BUNKER LAKE INDUSTRIAL PARK
BUILDING #5
Ramsey, Minnesota

BLIP V DEVELOPMENT PLANS

CITY OF RAMSEY, MINNESOTA

BUNKER LAKE INDUSTRIAL PARK FOURTH ADDITION

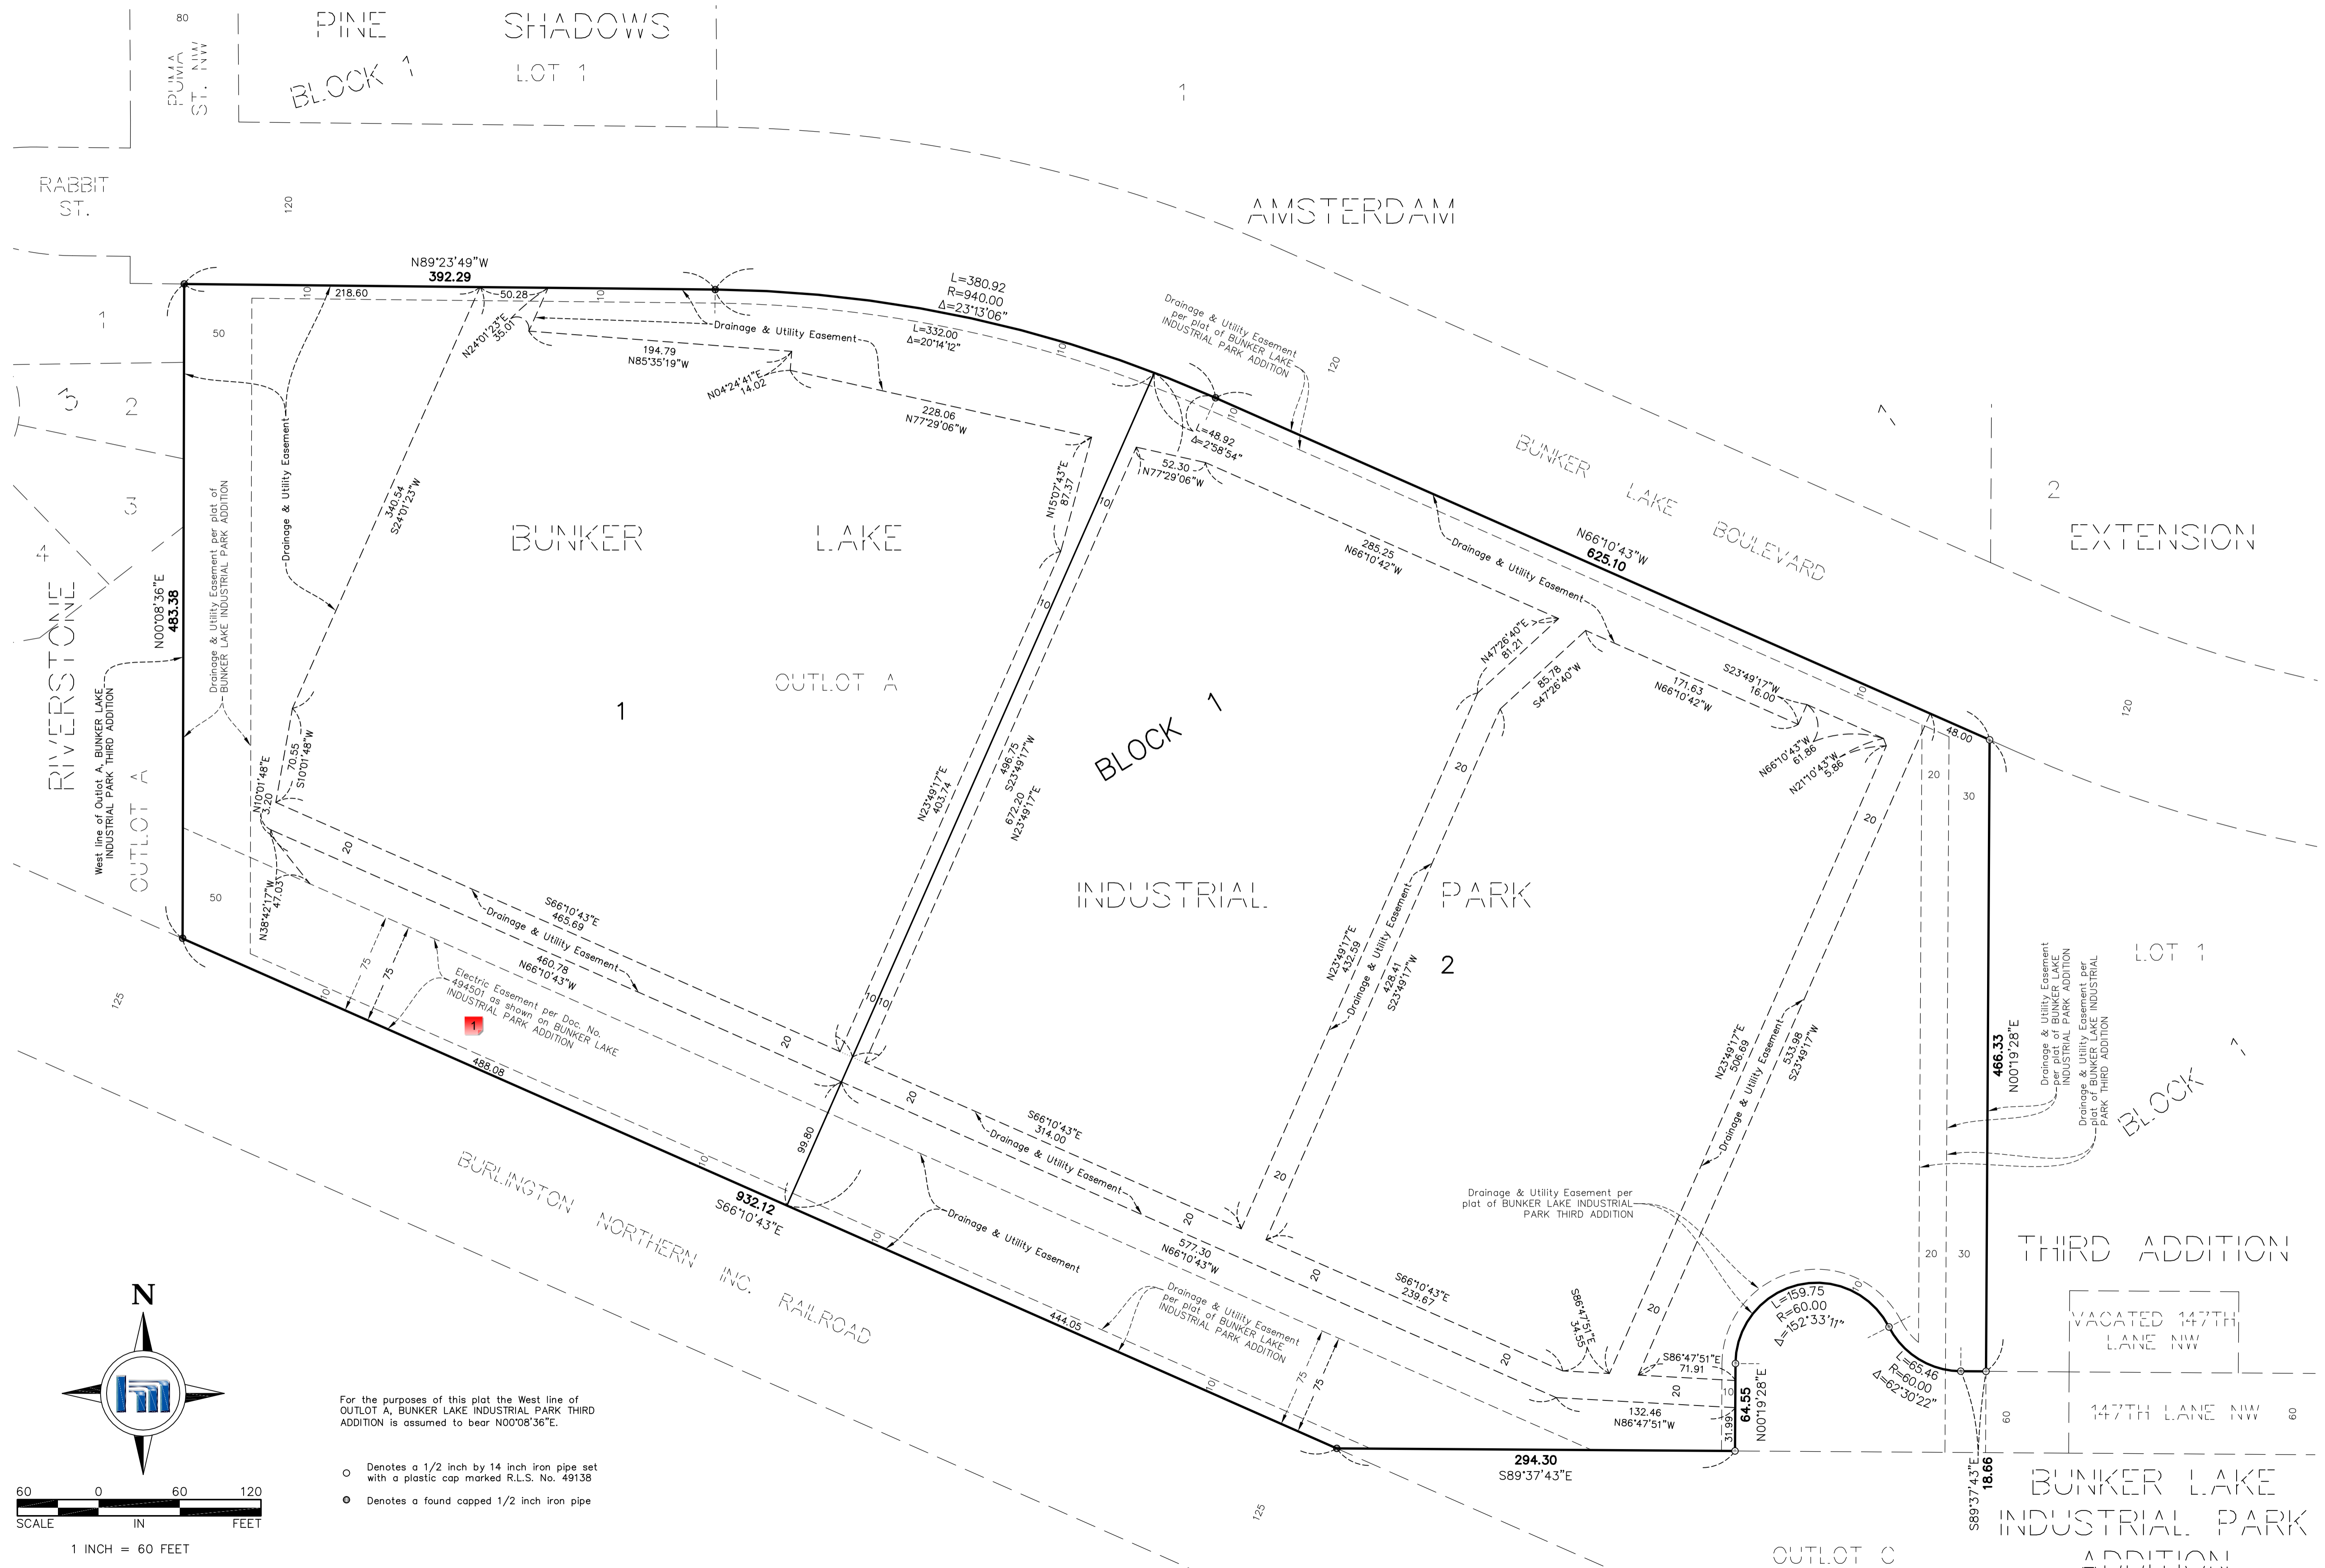
1 - Electric Easement

Verify the electric easement gives authority to build a pond.

GRADING AND EROSION CONTROL

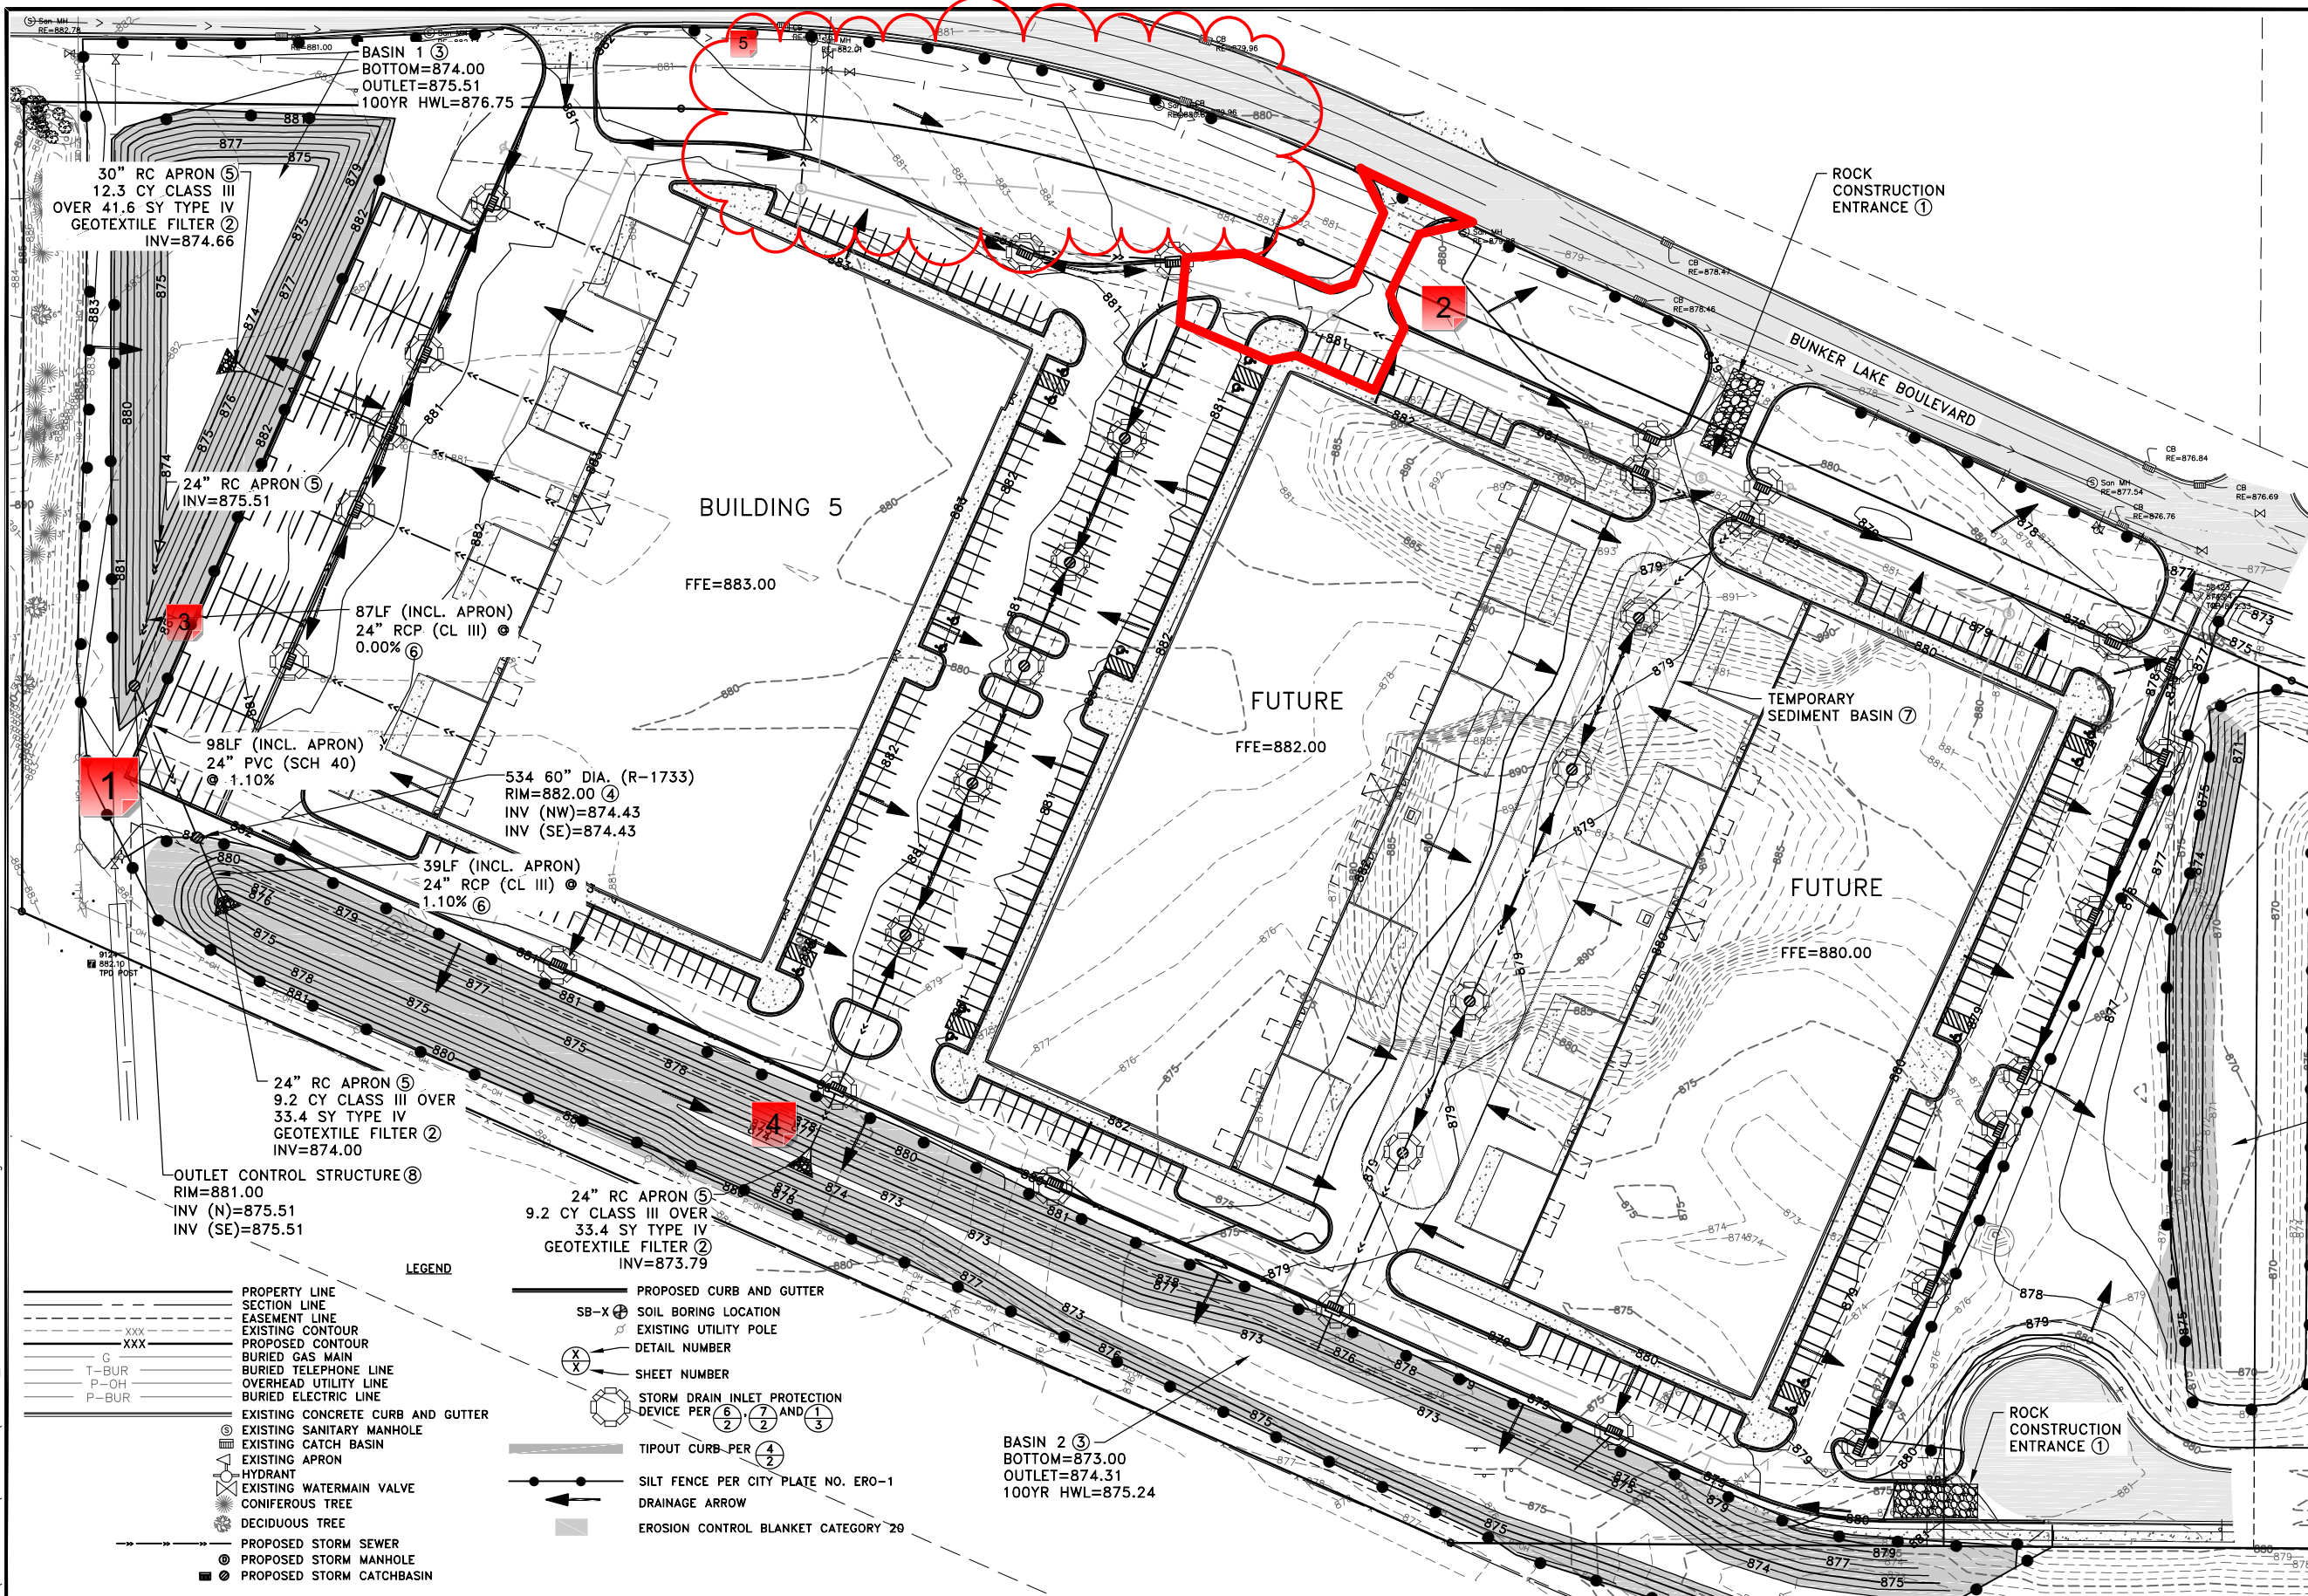
1 - Watermain Storm Crossing

This storm and water crossing looks like it will be similar in elevation, provide min 18" separation and insulate if less than 24"

2 - Flow direction

There are no arrows indicating flow direction in this area. After this first phase is constructed will water in this paved area make it to the catch basin to the West?

3 - 24" RCP Inlet

This run does not need all joints tied, just last three joints is plenty.

4 - 24" RCP Outlet

This run should probably have all joints tied. At a minimum last 3 joints

5 - Bunker - Boulevard Area in front of Bldg 5

It's difficult to figure out the contour lines, there's not many labels. But it doesn't look like minimum 2% slope is being met in the boulevard area between the back of curb in-front of Bldg 5 and Bunker Lake Blvd.

PAVING PLAN
 CITY OF RAMSEY, MINNESOTA

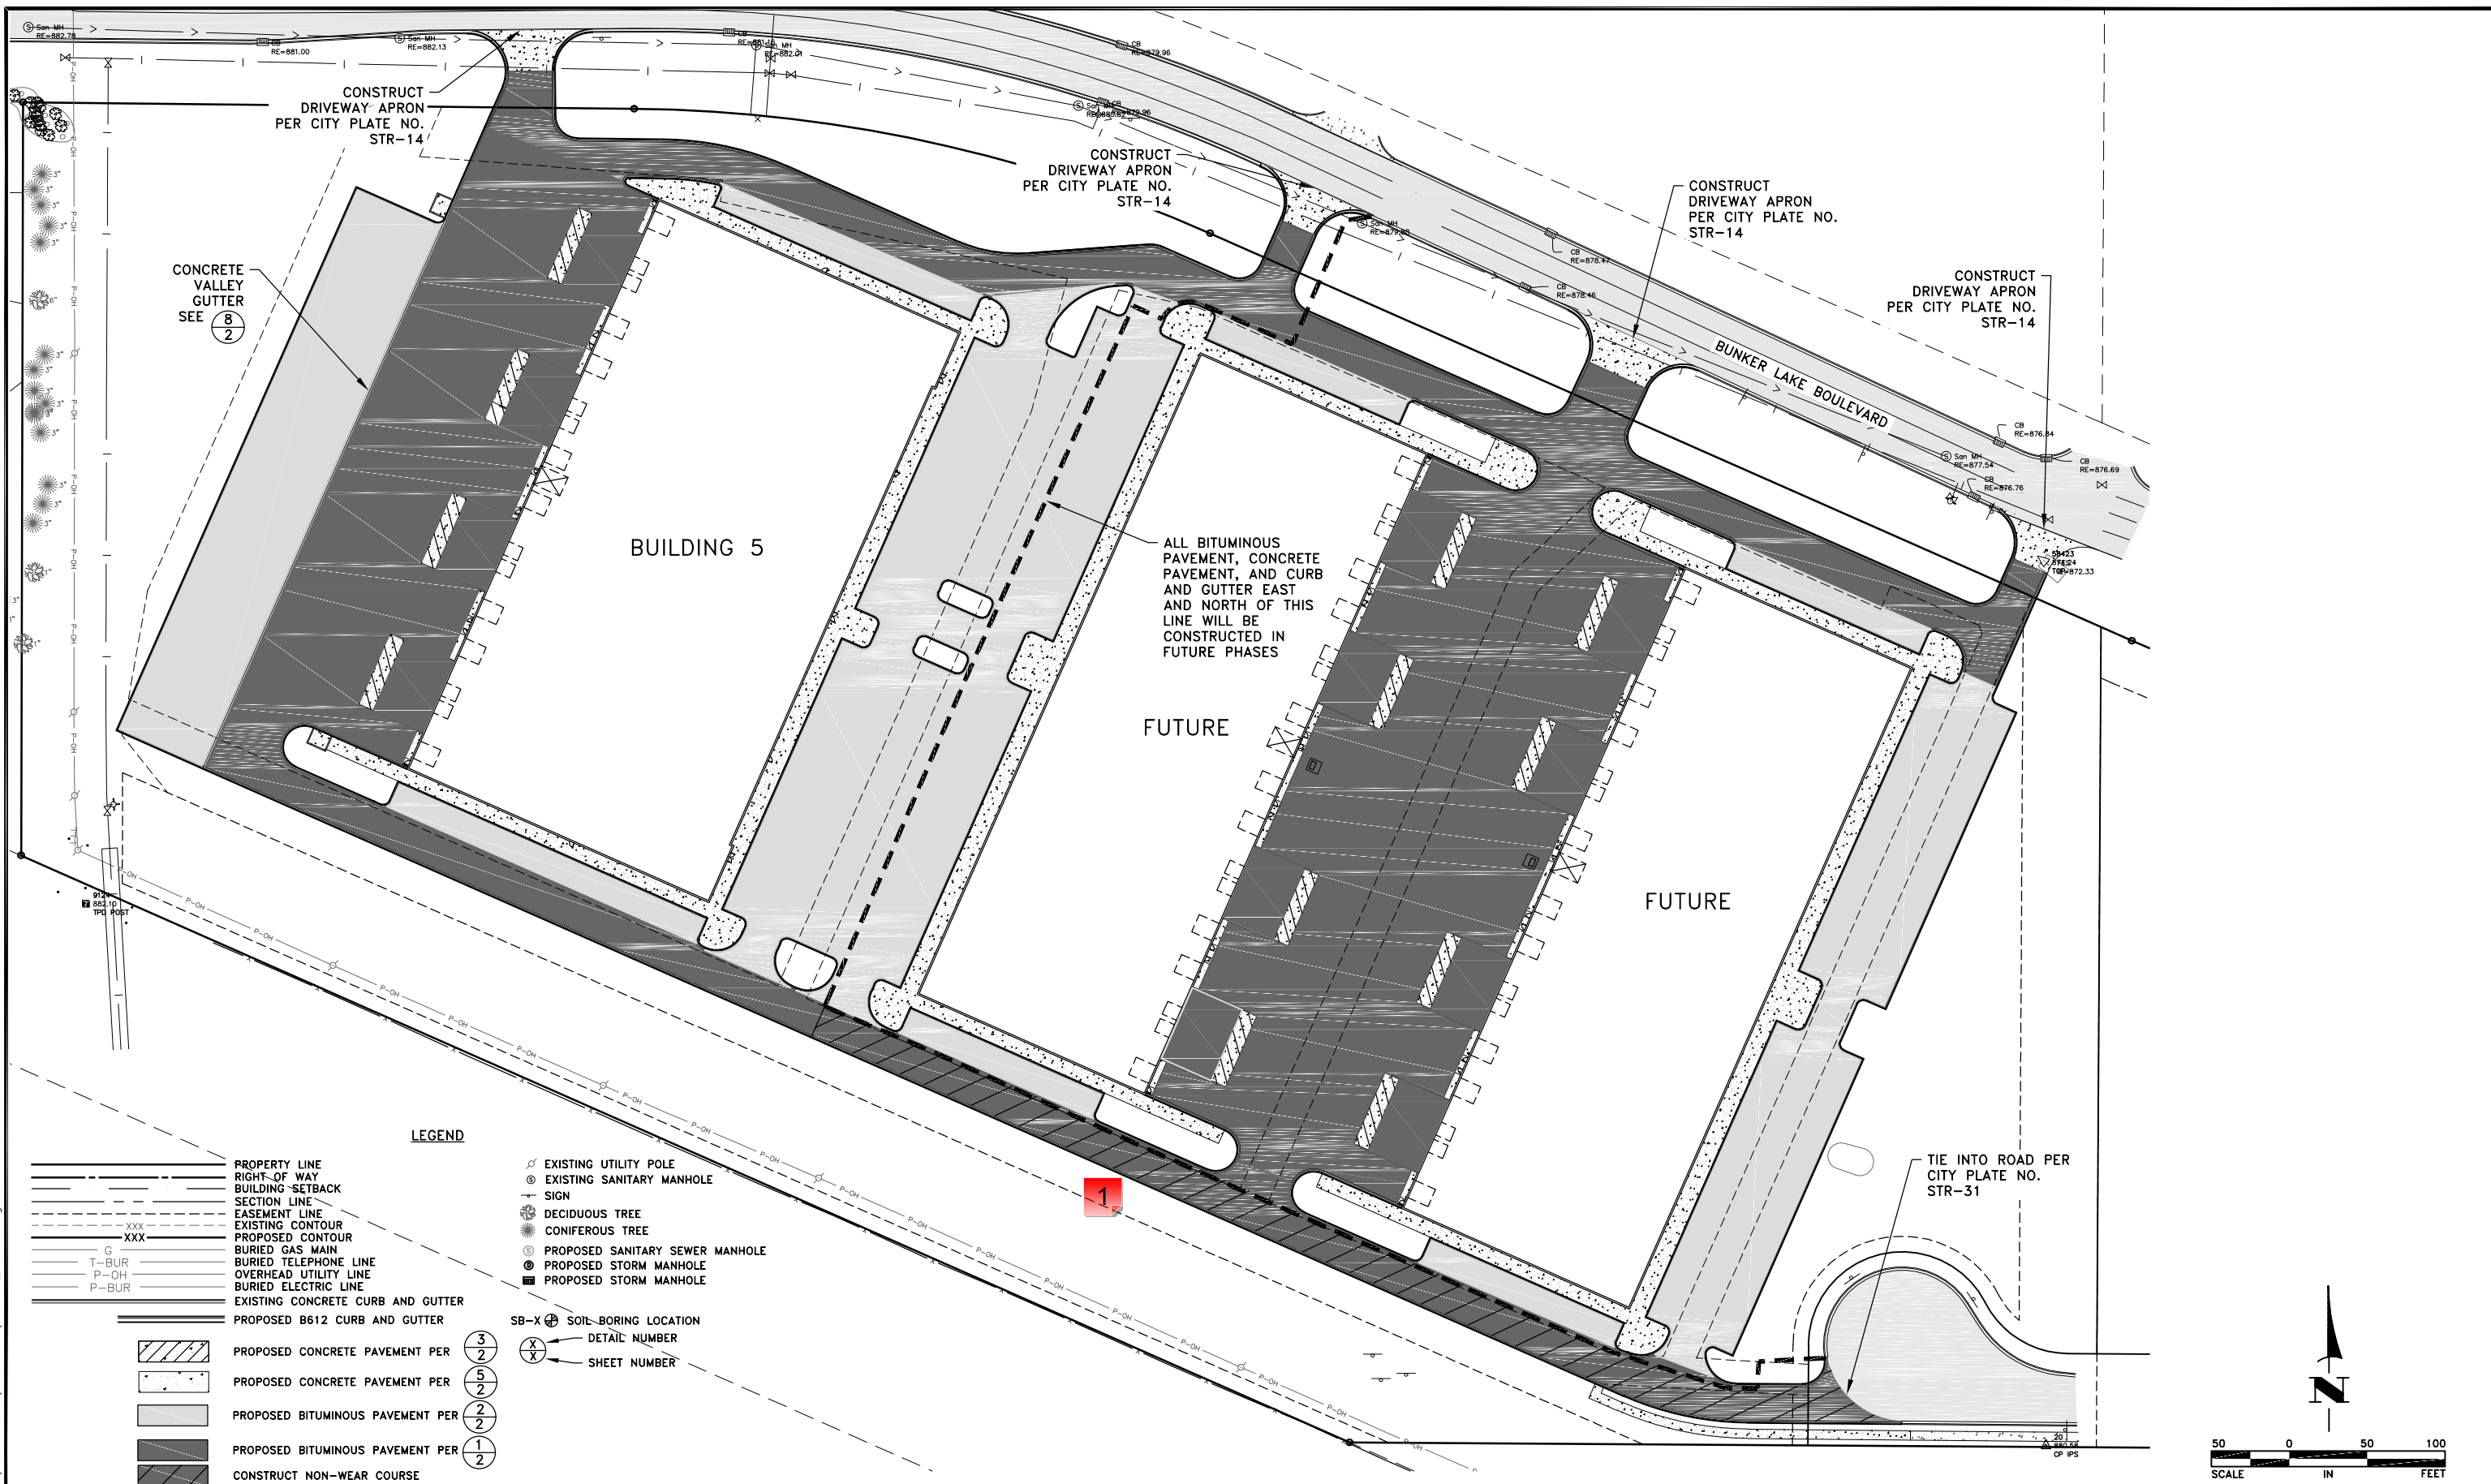
1 - Drive Aisle to the cul-de-sac

Is the pavement section going to be able to support heavy trucks without the wear course? I understand the idea to not potentially damage the wear course during future construction. But if a user for building 5 will have heavy trucks, may want to consider paving this wear course up-front..
